Planning Panels Victoria

Port Phillip Planning Scheme Amendment C219port South Melbourne Structure Plan

Panel Report

2 July 2026

Figure 7 Modelling for 113-127 York Street provided by Council

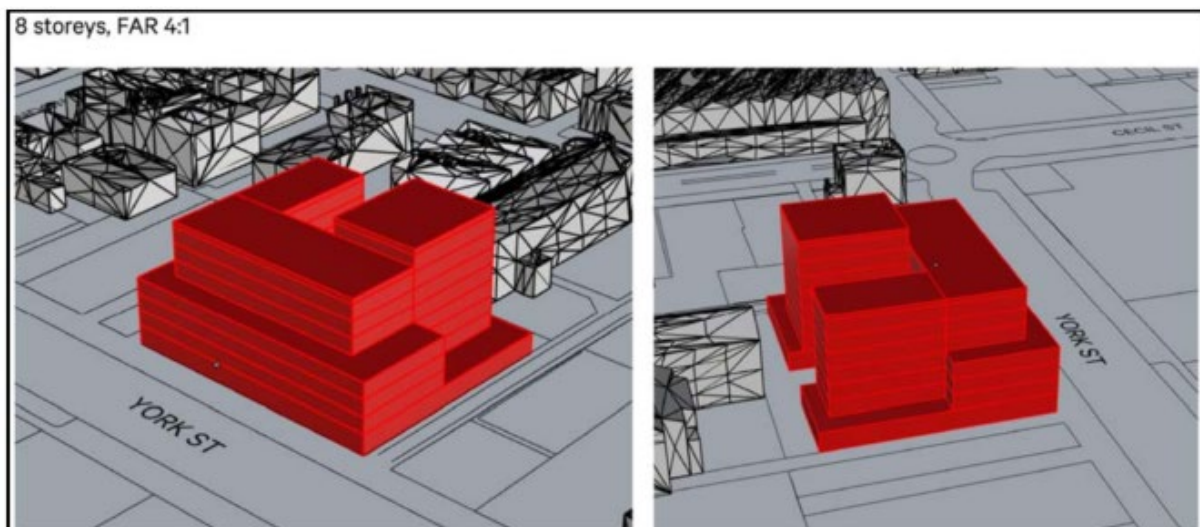
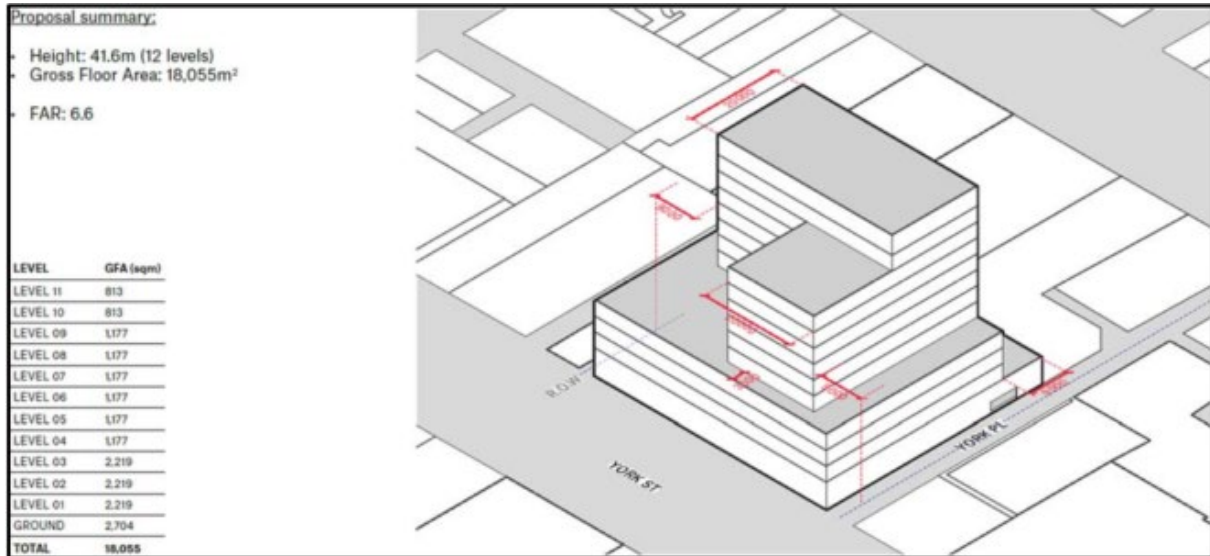
- the 4.5:1 FAR for 113-127 York Street is one of the poorest fitting in the Activity Centre, with testing showing about 7:1 was possible, so the control removes over half the accommodatable floor area, an arbitrary constraint inconsistent with State housing policy
- the Hodyl & Co testing (Figure 7) was critically flawed, relying on a single siting strategy with incorrect assumptions about 288 Coventry Street, no heritage advice and, as Mr McPherson observed, massing 'not commercially informed'
- modelling of 113-127 York prepared by Bates Smart Architects which it argued provided a superior urban design outcome with a higher FAR (Figure 8).

- in Plan 1 of DDO40, change the FAR on 216–220 York Street from 5.0:1 to 5.5:1
- in Plan 1 of DDO37, remove the FAR for the Clarendon Centre at 245–271 Clarendon Street, South Melbourne, excluding the Coles site and replace it with Envelope control
- in Plan 1 of DDO39, amend the FAR to 5.5:1 and in Plan 2 amend the building height to 28.2 metres/7 storeys of DDO39 for 24 Eastern Road, South Melbourne.

Figure 9 Riverlee testing for its properties in the CRIT

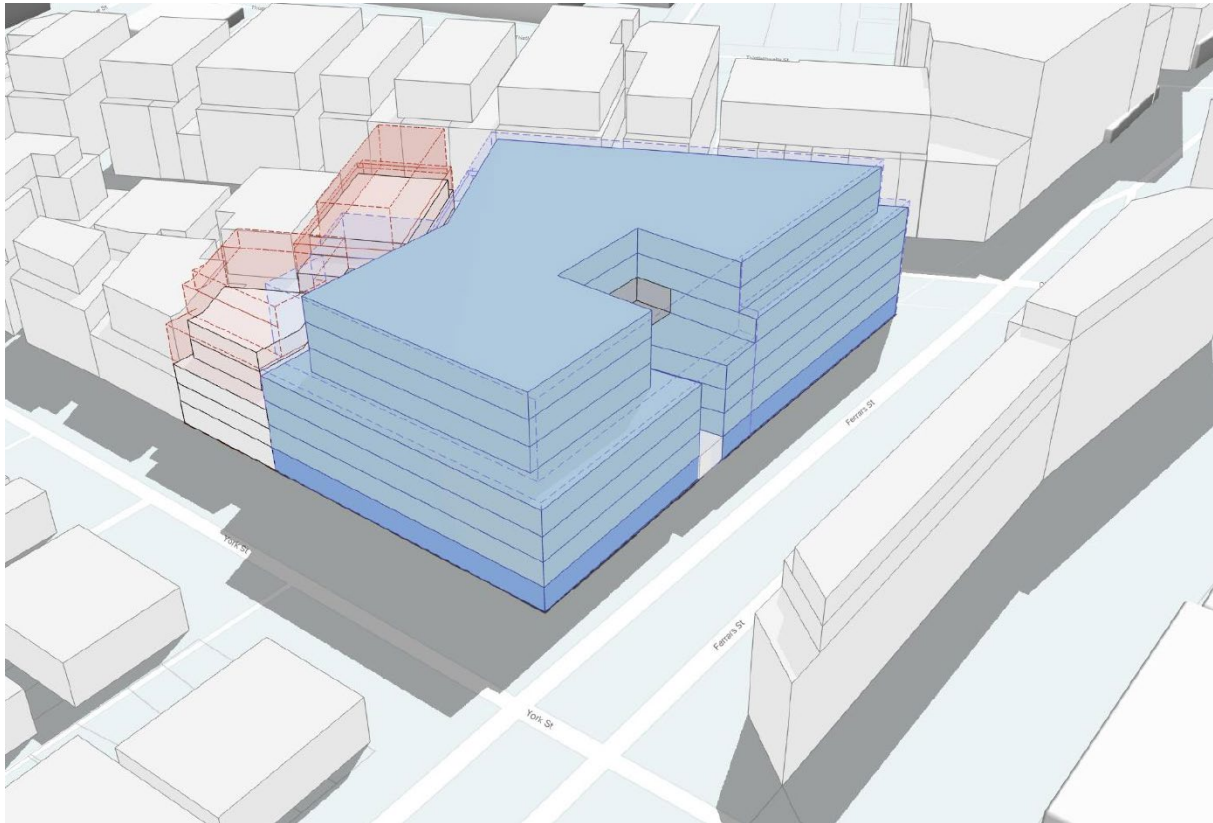
Riverlee raised concerns about mandatory FARs on unconstrained sites such as the CRIT and the Riverlee Land. Accepting mandatory FARs in principle, it submitted (relying on Mr Sheppard) that they need careful, transparent calibration and that the Riverlee FARs showed inconsistent testing, with scenarios such as 6.0:1 not modelled. It preferred discretionary FARs, citing Arden, Central Geelong and Epping and recommended its FAR should be increased to 6.0:1.

Mr Sheppard's evidence was that the exhibited DDO40 applies a mandatory FAR of 5.5:1 across most of the property, stepping to 5.0:1 for 216 to 220 York Street and that his testing showed about 6.0:1 can be accommodated within the preferred envelope with acceptable amenity (Figure 9), the proposed FARs being an overly 'loose fit' that underutilises the site.

4.3 City Edge, 89 and 99 Eastern Road and 36A and 58A Napier Street South Melbourne (HO561)

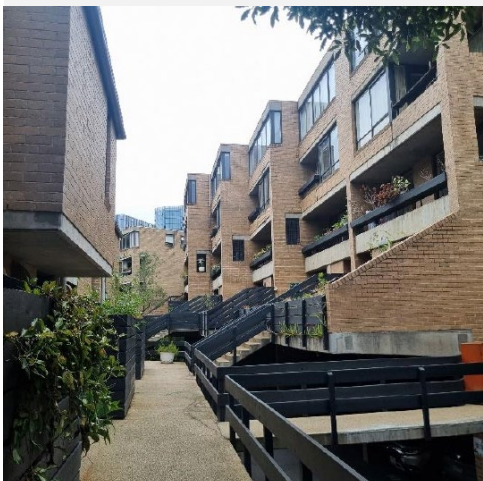
observed that there are many properties on the site given that each unit was given its own distinctive street address as part of the scheme. Therefore, the citation should be updated to include specifically the Park Street properties, as well as amended to include the range of street addresses on Napier Street as shown in Figure 12.

- a. to separate the discussion of Criteria D and E to differentiate the place's representative significance**
 - b. amend the historical outline to clarify that the development was a private project rather than a Housing Commission of Victoria project**

- 7. Correct the addresses and mapping for City Edge to include the whole of the complex as mapped on VicPlan.**
- 8. Amend the citation for 167-173 Coventry Street, South Melbourne (HO566) to reference the Albert Road Clinic and Offices at 31-33 Albert Road as another known Lumsden design within Port Phillip.**

Figure 13 Melbourne Water climate change 1% AEP flood depth

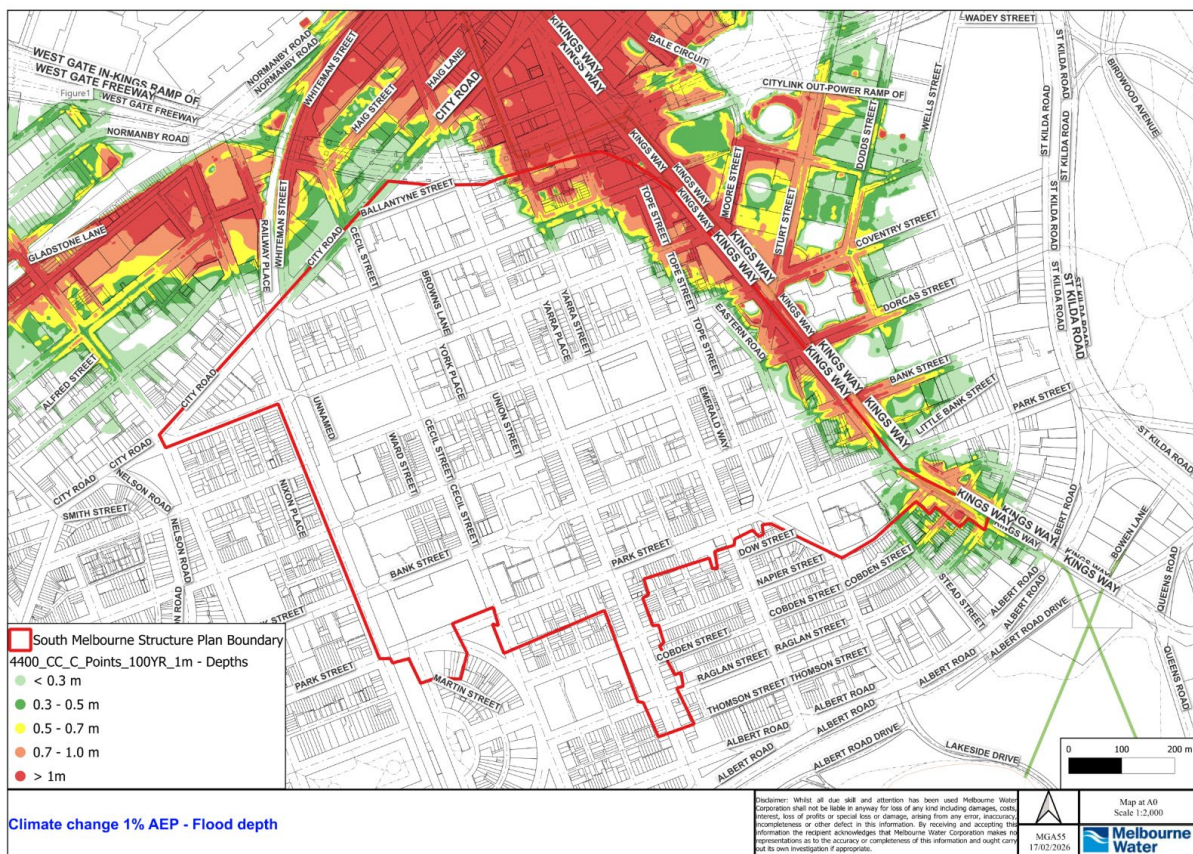
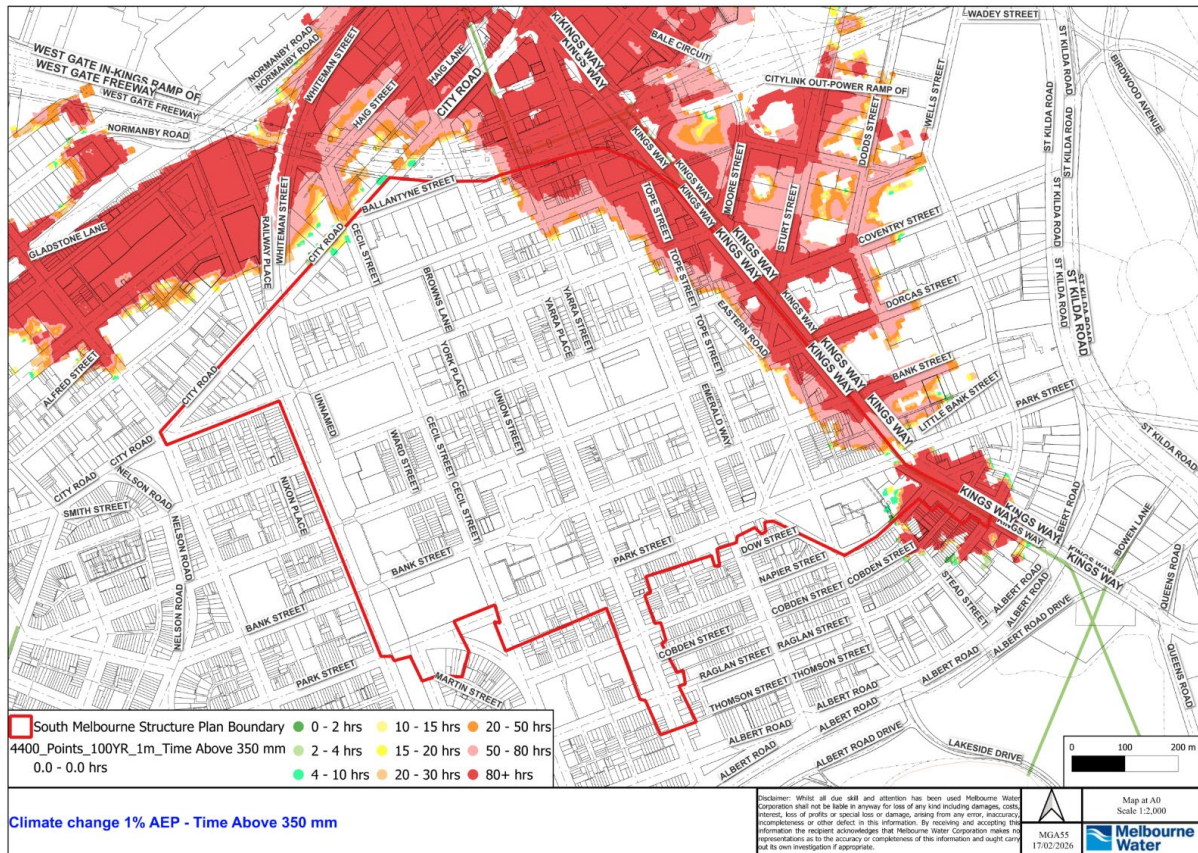
Melbourne Water submitted the following two maps, Figure 13 and Figure 14, detailing the extent and depth of a 1% AEP event in the SMSP area.

Melbourne Water submitted that replacing DDO8 with DDO39 enables taller buildings and higher densities across the SMEP East and the KWMUC, increasing the population exposed to flood risk. It rejected Council’s reliance on mandatory FARs, maintaining that any increase in density within flood-affected areas is unacceptable regardless of FAR limits. The 2100 climate-change mapping (Figures 13 and 14) shows extensive deep flooding and prolonged inundation, particularly along Kings Way, with depths often exceeding 0.7 to 1.0 metres and isolation lasting more than 80 hours, exceeding the DELWP safety thresholds for both residential and office development under current and climate-change scenarios. In its view the Amendment is poor strategic planning because development likely to be refused at permit stage under the DELWP Guidelines is being encouraged at the scheme level. It stated that flood risk should be resolved during strategic planning, at a precinct scale, rather than deferred to individual permit applications.

The flood and climate change provisions in DDO39 are appropriate and the flood-affected areas of DDO39 should not be removed from the Amendment.

Figure 16 Comparison of building heights in DDO8 and the Amendment DDO schedules

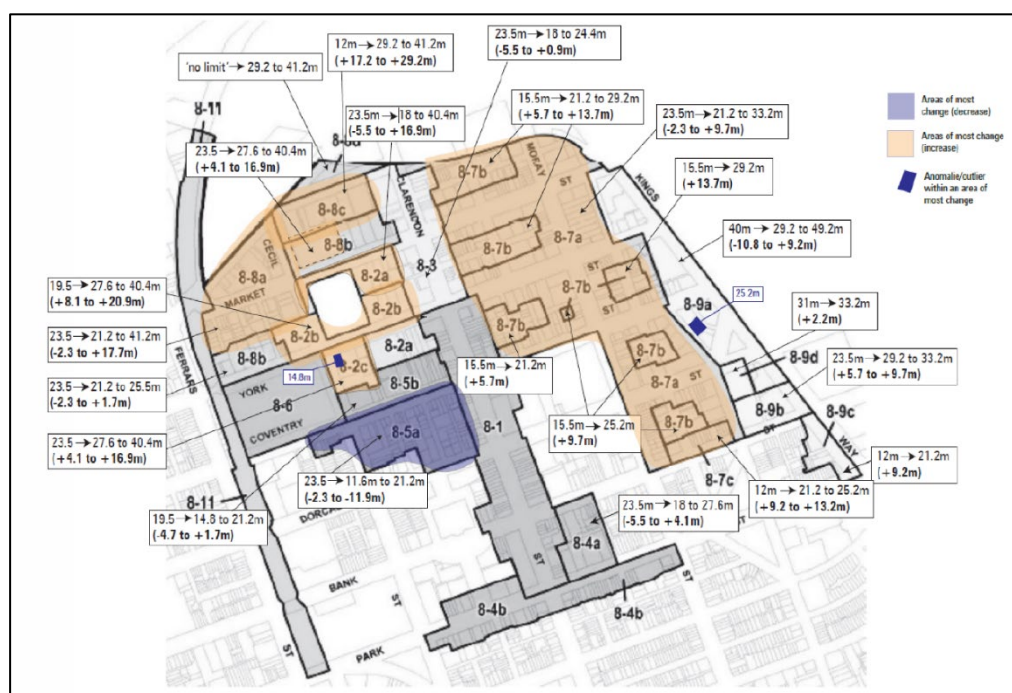
Council rejected Melbourne Water's suggestion to remove flood-affected land along Kings Way from the Structure Plan, since that land is already zoned for intensive redevelopment (primarily MUZ), subject to the SBO and existing DDO controls and already capable of higher-density development, so that inclusion allows flood risk to be managed explicitly rather than ignored. In support of that proposition Council provided a reviewed version (Document 81) of Mr Barnes's comparison of the building heights in DDO8 and the proposed DDO schedules (Figure 16).

Plan 1: Floor Area Ratio to Schedule 37 of Clause 43.02

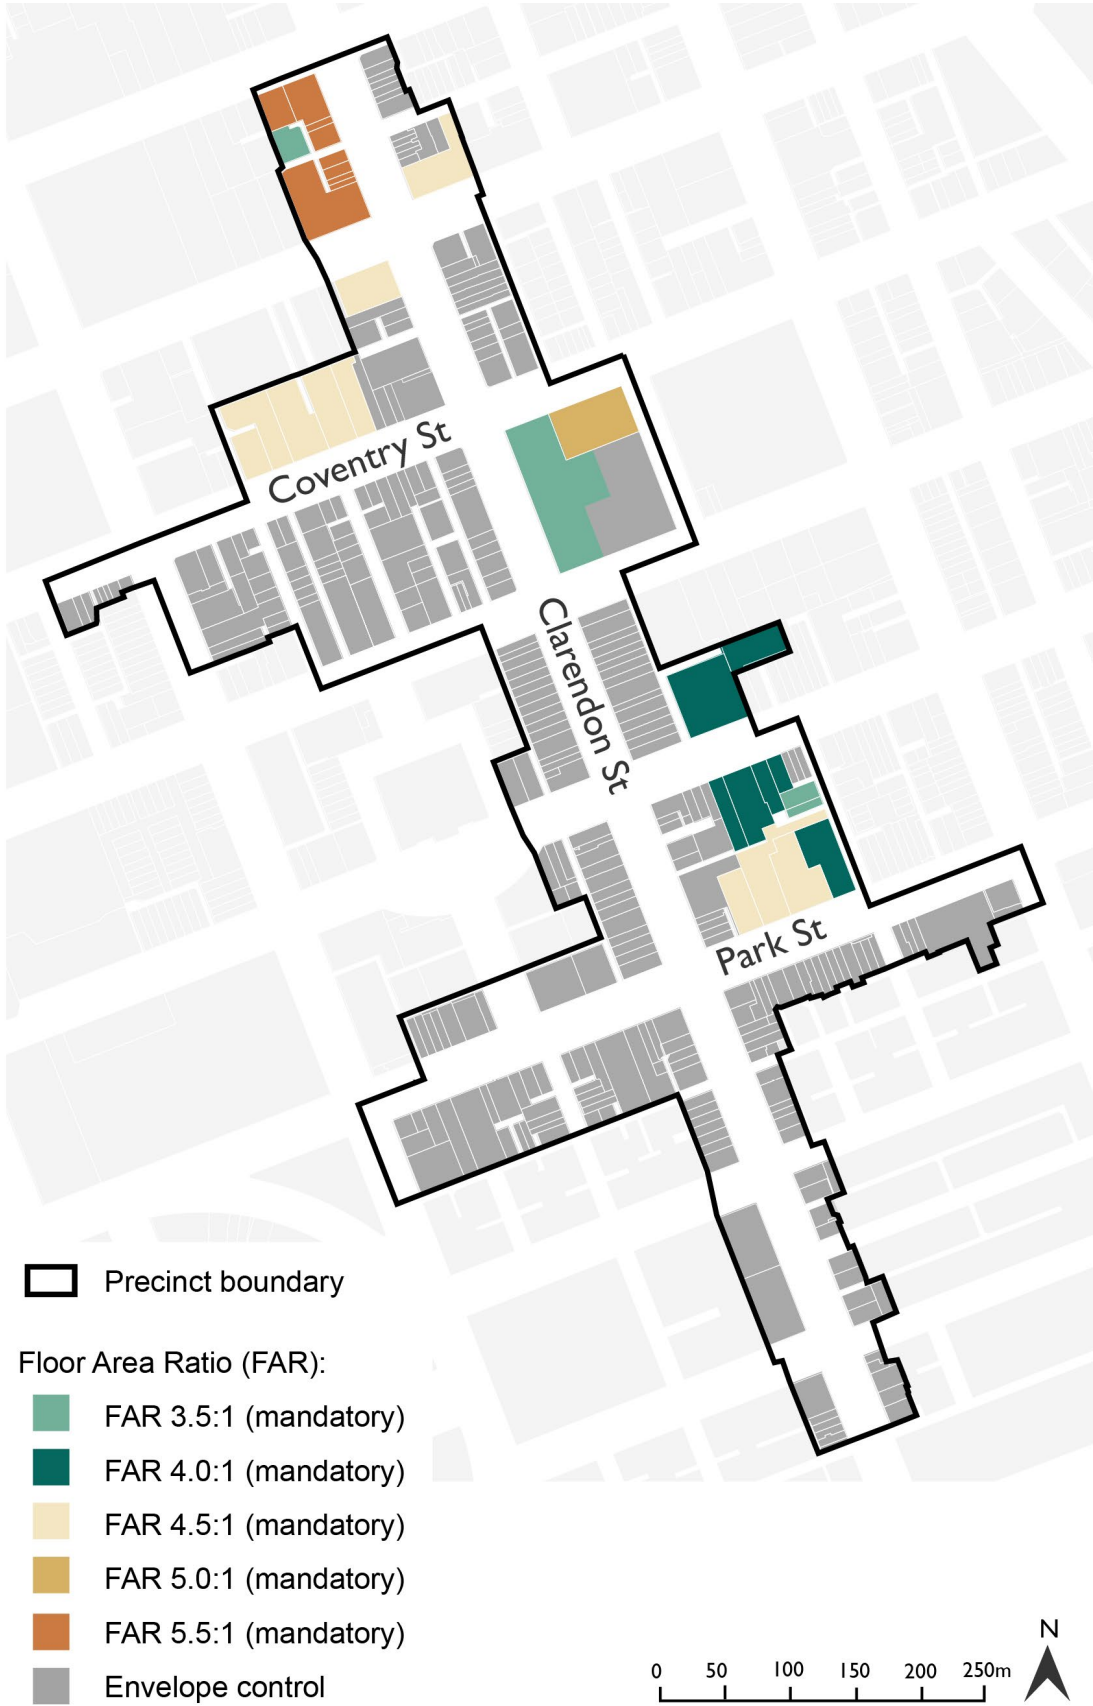
~~A permit cannot be granted or amended to vary this requirement, unless in the case of an amendment to a permit, the amendment does not increase the extent of non-compliance.~~

- 1. Amend Design and Development Overlay Schedule 37, as shown in Appendix D and:**
 - a. remove all reference to 'mandatory' from Plan 1**
 - b. add all street names to Plans 1, 2 and 3**
 - c. in the legend of Plan 3, change 'retain existing street wall (mandatory)' to 'Pre-existing street wall height (mandatory) or see clause 2.4-6'**
